Appendix J: Phase 1 Comments and Responses  
Attachments

CENSE would like the opportunity to dispute some of the “facts” stated by PSE representative Keri Pravitz before the Bellevue City Council on March 7, 2016.

# Load Flow modeling for "Energize Eastside"

Figure 4: PSE’s graph shows customer demand exceeding system capacity in 2018.<sup>2</sup>

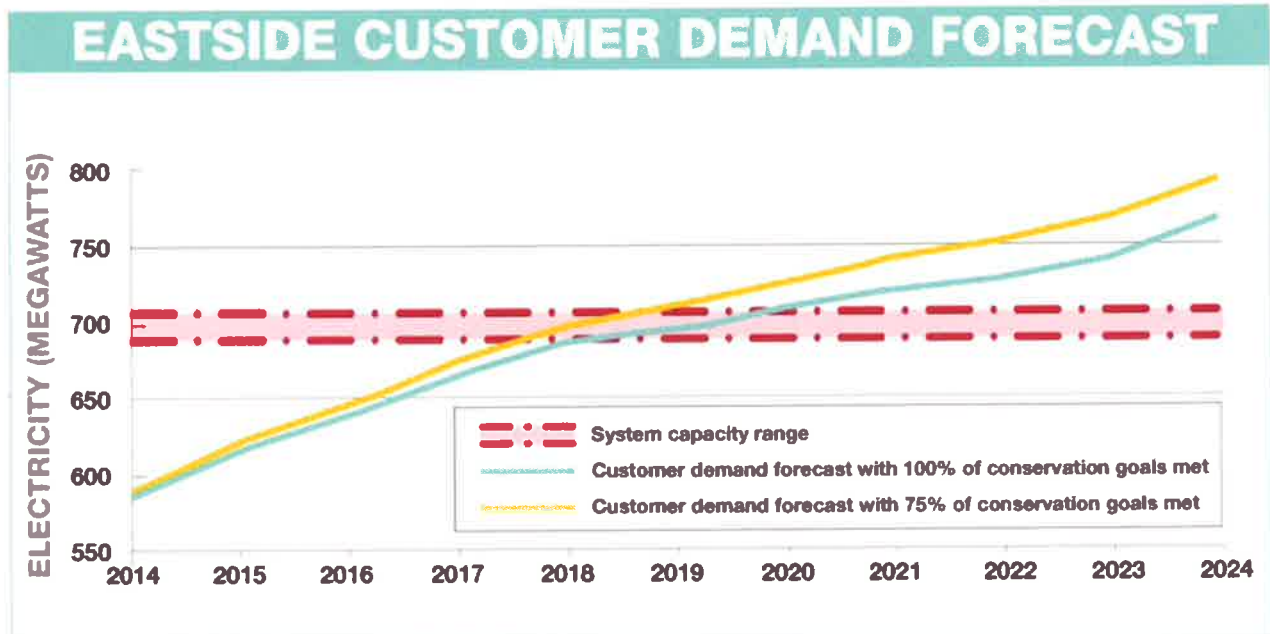
Concerns about future capacity are illustrated in Figure 5, PSE’s demand forecast graph.<sup>2</sup> This graph raises several questions. For example, it’s not clear how PSE determined the “System capacity range” of approximately 700 MW. If this value is derived from the transformer capacities listed in the WECC Base Case, these capacities are set to default values corresponding to “summer normal” conditions.

PSE’s graph shows Customer Demand growing at an average rate of 2.7% per year. However, data submitted by PSE to WECC shows a growth rate of only 0.5% per year. An explanation of this discrepancy is necessary to understand this graph.

Figure 3: PSE 2015 IRP *Figure 5-21: Electric Peak Demand Forecast before DSR 2015 IRP Base Scenario versus 2013 IRP Base Scenario Hourly Annual Peak (23 Degrees, MW)*

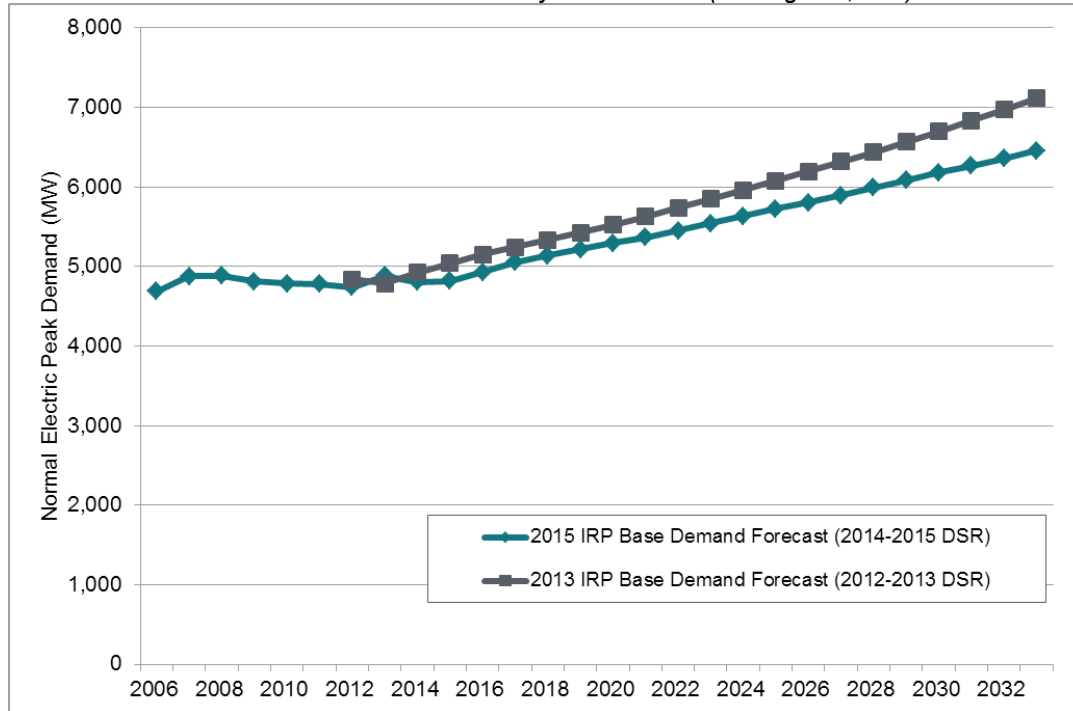
Figure 2 below shows how peak load is historically flat, then suddenly takes off in the future. You'll find this to be true with PSE's previous peak load forecasts. I understand that forecasts are, by their nature are wrong, but PSE has a habit of overestimating peak load.

Figure 5-27: Electric Peak Forecasts by County (MW), after applying 2013 IRP DSR

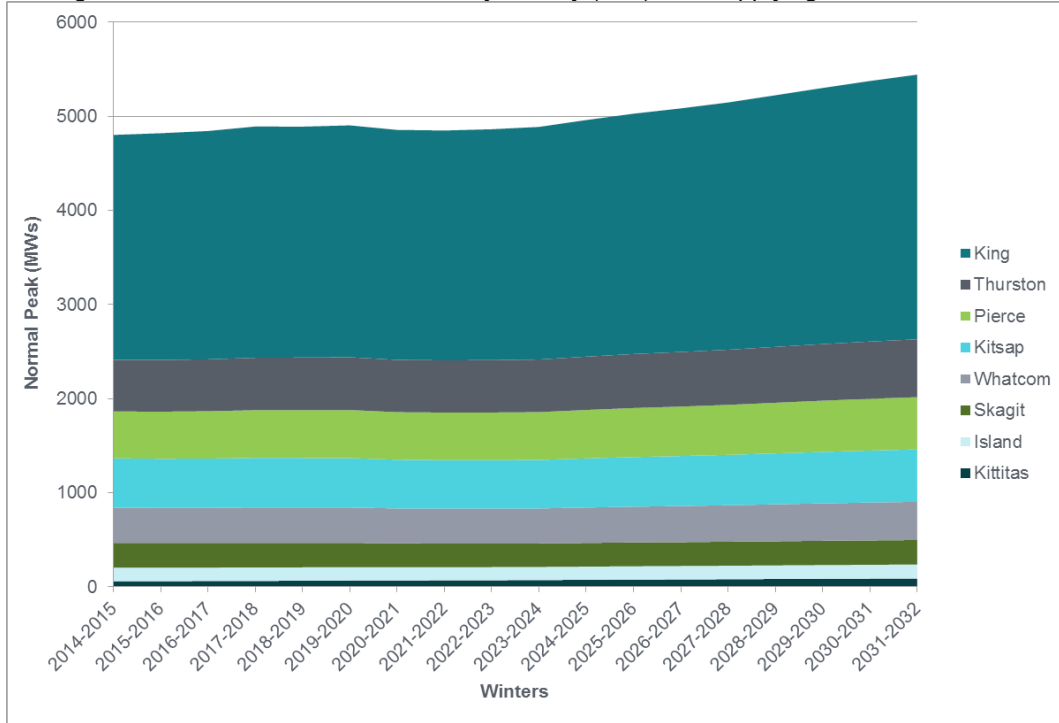
**Notice in Figure 5-27 from PSE's 2015 IRP, the peak demand does not begin to increase until 2024.**
